# Access Compliance Report

## Public Rights-of-Way

### (Curb Ramps)

Intersection ID: 12011	Main Street: E_16TH_ST	Cross Street: HARRILL_ST	Location:	S
ADA ID: 38E5B2EBBBE8	Ramp Type: BlendTrans1	Initial Pass/Fail: Fail	Overall Compliance: No	Severity Score: 60

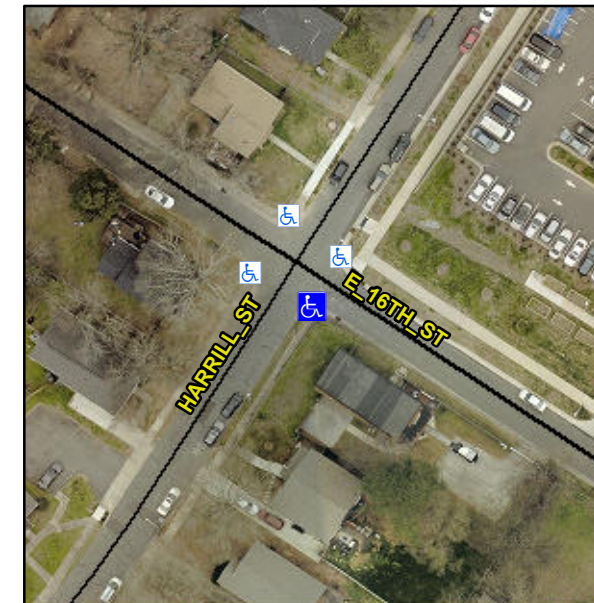
Possible Solutions:

**Remove & Replace Curb Ramp With Two New Directional Ramps or Equivalent.**

**Not Found, R304.5.1, R304.5.3**

Compliance	Description	Data	Compliance	Description	Data
N/A	Ramp Length (in)	48.0	Yes	BlendTrans Slope (%)	2.7
No	Ramp Width (in)	29.0	No	BlendTrans XSlope (%)	7.9
N/A	Flare Type LT	N/A	N/A	Flare Type RT	N/A
N/A	Flare Slope LT (%)	N/A	N/A	Flare Slope RT (%)	N/A
N/A	Flare Traversable LT?	N/A	N/A	Flare Traversable RT?	N/A
N/A	Landing Length (in)	N/A	N/A	DWS Provided?	N/A
N/A	Landing Width (in)	N/A	N/A	DWS Contrast?	N/A
N/A	Landing Slope (%)	N/A	N/A	DWS Length (in)	N/A
N/A	Landing X Slope (%)	N/A	N/A	DWS Full Width?	N/A
N/A	Landing Curb? (Y/N)	N/A	N/A	DWS Offset (in)	N/A
N/A	Shared Landing?	N/A			
N/A	Gutter Ponding?	N/A	N/A	Gutter Slope (%)	N/A
N/A	Gutter Lip Ht (in)	N/A	N/A	Gutter X Slope (%)	N/A
N/A	Painted X Walk1?	No	N/A	Painted X Walk2?	No
	X Walk 1 Direction	To NE		X Walk 2 Direction	To NW
	X Walk 1 Width (in)	N/A		X Walk 2 Width (in)	N/A
	X Walk 1 Slope (%)	3.5		X Walk 2 Slope (%)	4.0
	X Walk 1 X Slope (%)	3.5		X Walk 2 X Slope (%)	6.3

N/A	Ramp inside XWalk1?	N/A	N/A	Ramp inside XWalk2?	N/A
	Road Slope (%)	5.4		Clear Space?	N/A
	Road X Slope (%)	1.7	N/A	Clear Space to XWalk (in)	N/A
N/A	Any Obstructions?	N/A	N/A	Storm Grate/Utility Hazard?	N/A
	Obstruction Type			Storm Grate/Utility Type	
		N/A			N/A
			Yes	Surface Condition? (G/P)	Good
			No	Curb Slope (%)	22.2
